Environmental Review Team Report

Executive View Estates

Middletown, Connecticut

August 1978

PRELIMINARY SUBDIVISION PLAN

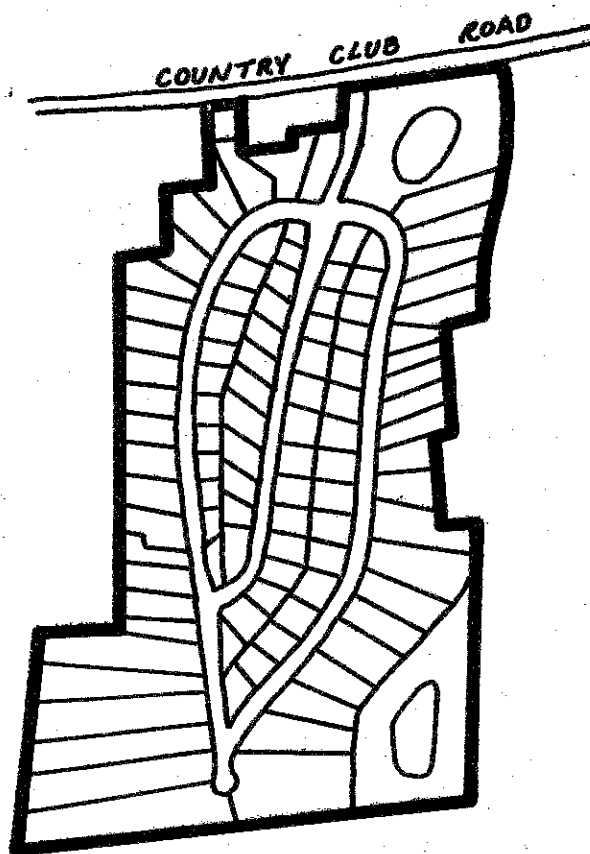
The proposed Knox subdivision plan, dated May 9, 1978, and showing 100 lots, appears to be too intensive for this site. The lot arrangement does not take into account the site's steep terrain or the practical aspects that future homeowners will have to contend with in lawn maintenance, driveway access and snow removal.

The proposed road layout does not provide for the future option of inter-connection with White Road. As shown on the preliminary plan (May 9, 1978), the road system serving 100 homes would actually be dead-end. If possible, a road system that permits a second exit/entrance into this development would be desirable.

The Team recommends that the City and developer consider the land use recommendations for this parcel as presented in the 1965 Middletown Plan of Development. The 1965 Plan recognized this site's natural constraints and recommended its future use as a rural residential area of acre lots or larger. The provision of water and sewerage utilities to this site have not lessened the basic natural development obstacle - the presence of steep terrain. The proposed preliminary site design seeks a density that squeezes development onto this parcel as dictated by public utilities rather than by accepting the parcel's natural features and geographic opportunities.

graphy should include the reservation of the excessively steep terrain for open space, the reduction in overall site density to lessen land coverage and storm water run-off; the elimination of the proposed Knox Boulevard to reduce the need to excavate through the steepest parts of the site and the location of home sites on slopes in excess of 15%; and the arrangement of lots and placement of houses to take advantage of the views from the site.

Figure 1.
Watershed affecting the
culvert on Country Club
Road.
▼ Location of culvert.

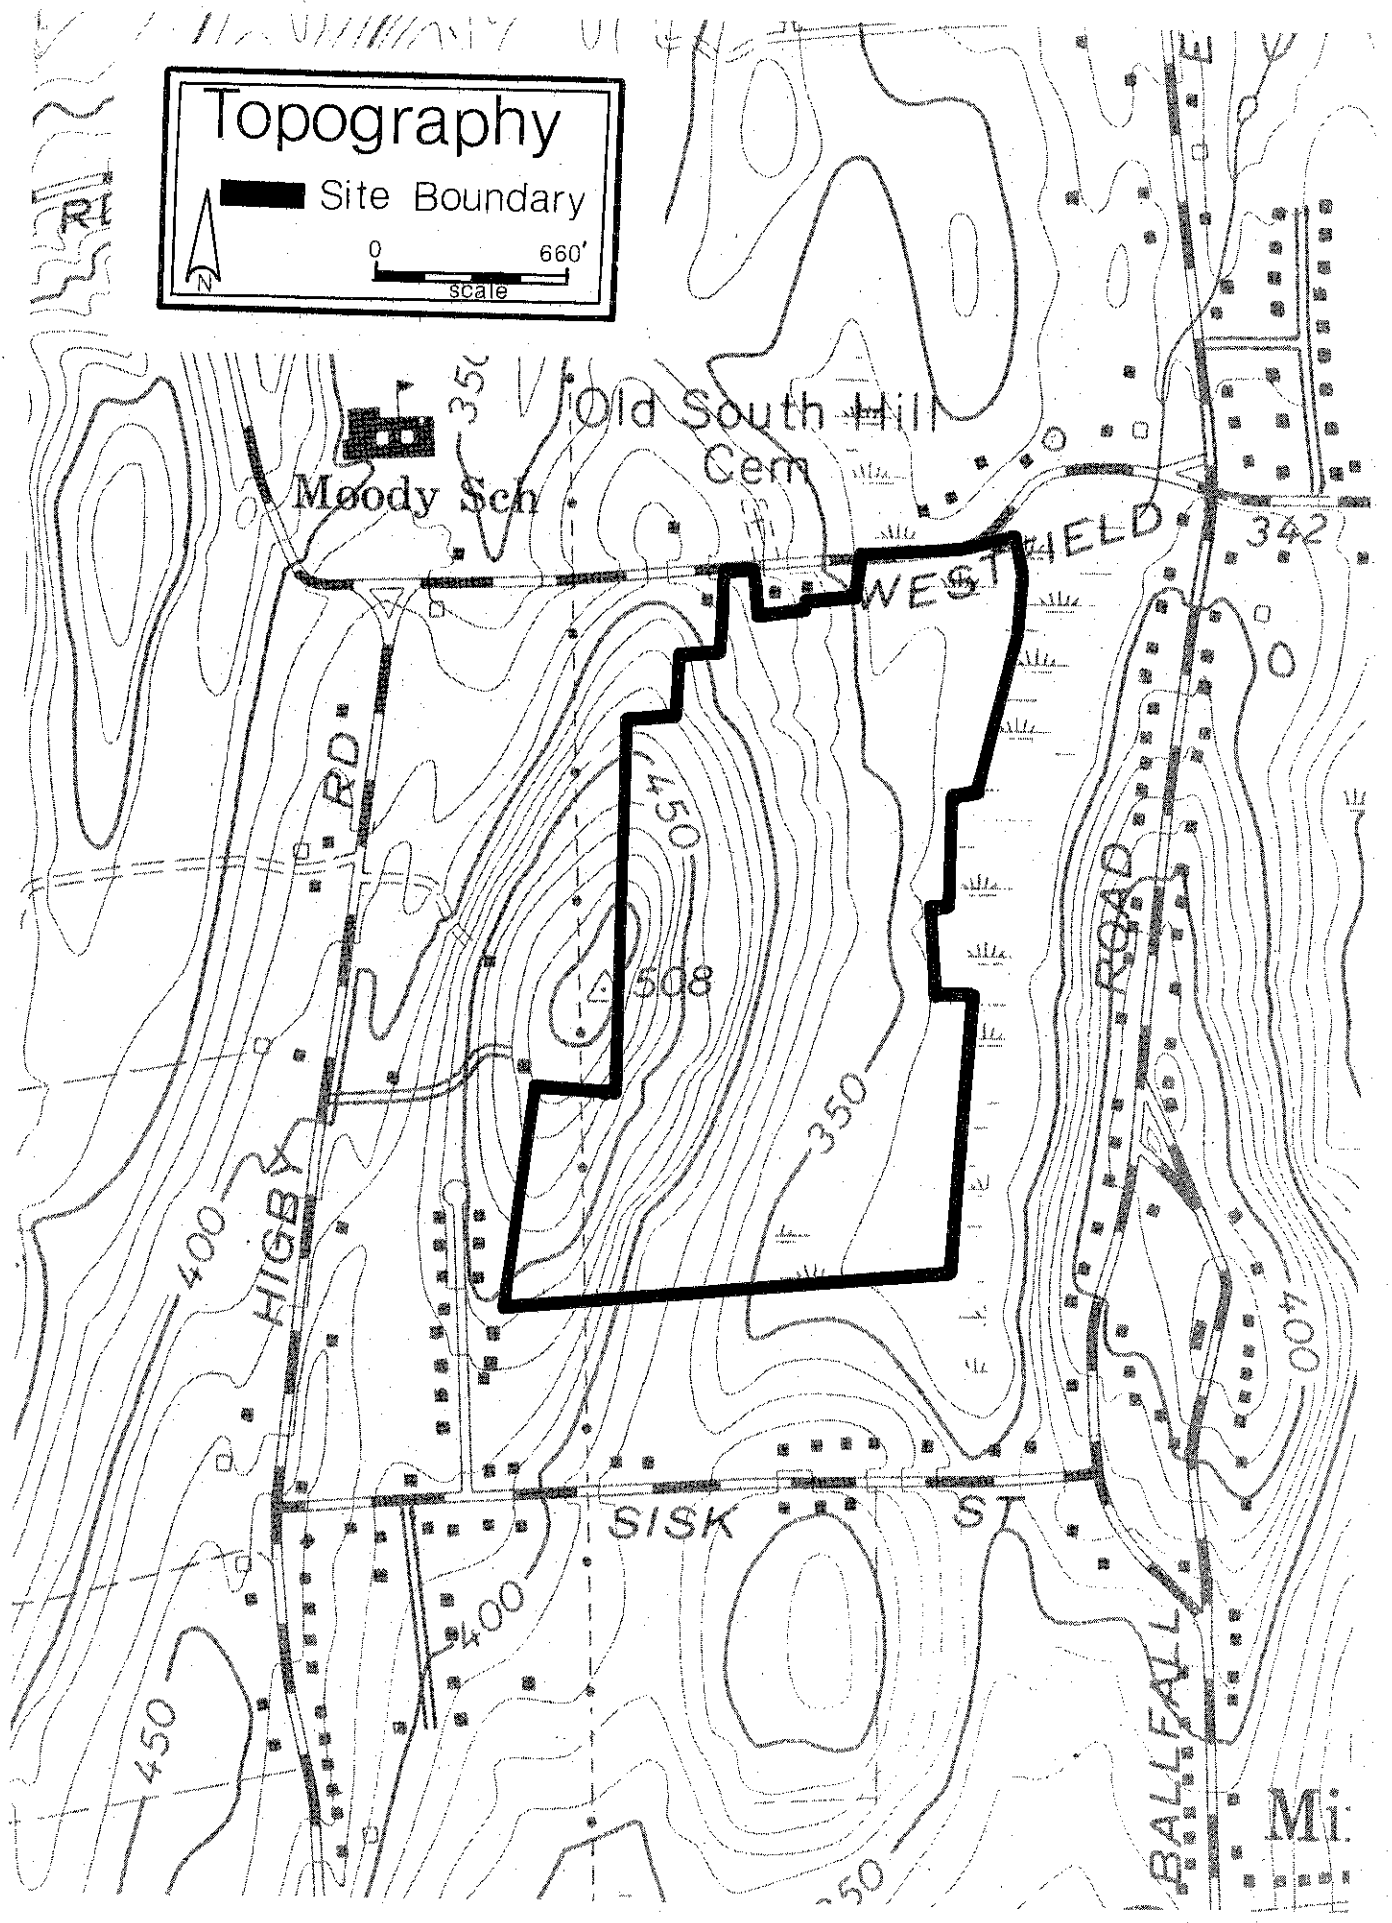
through the culvert is not derived only from the Knox property; the total drainage area, shown in the accompanying illustration, contains approximately 200 acres. Completion of the subdivision would increase the volume of runoff for any specific-frequency storm event, such as the 50-year storm. The additional runoff, in turn, would increase peak flows in the culvert unless engineering measures were taken to prevent this. Flow in culverts along East Miner Brook north of Country Club Road would also be increased somewhat, with the percentage of the increase diminishing progressively downstream.

These considerations do not mean that the retention basins, as designed, would allow an increase in peak flows at the culvert; indeed, the structures could actually reduce such flows. The main concern, however, is that the developer's present hydrologic analysis is not actually set up to address the problem at the culvert itself, and therefore cannot be used to predict future peak flows at that point.

For a more detailed determination of potential flooding problems in this watershed, and specifically at Country Club Road, the Team recommends that the Inland Wetlands Commission retain the services of a professional consulting hydrologist.
